BP - San Juan Wellwork Procedure Plug & Abandonment

HEATH GC C 001-MV 30-045-09154-00

Proposed Wellbore Diagram

Re: Permanent Abandonment Well: 1 Heath Gas Com C

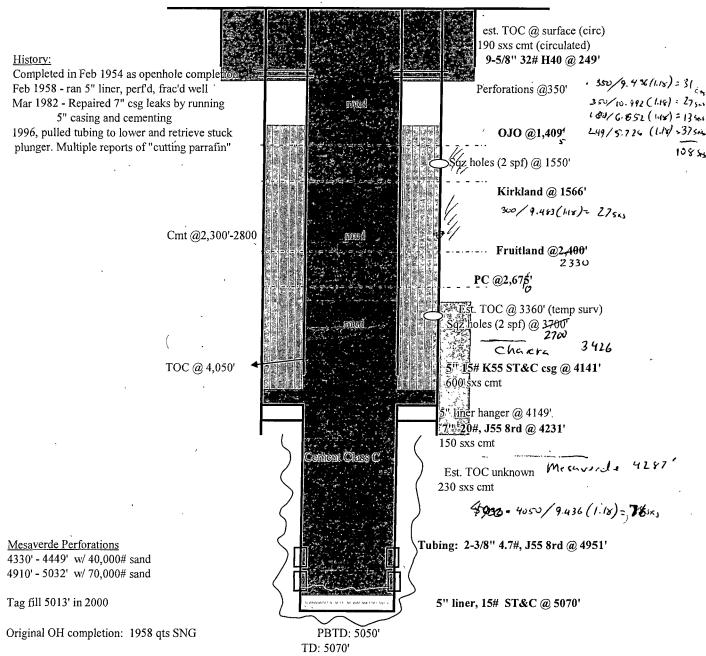
* Bring PC/Foutland	tup tu 2280' (2800'- d bottom to 1618' (1618'		/cc of OIL CO	ORGUST 3

Plug Chacre 34,76-3376

- 1. Plugging operations authorized are subject to the attached "General Requirements for Permanent Abandonment of Wells on Federal and Indian Lease."
- 2. Farmington Office is to be notified at least 24 hours before the plugging operations commence (505) 599-8907.
- 3. The following modifications to your plugging program are to be made:
- a) Place a cement plug from 3476' 3376' to cover the Chacra top.
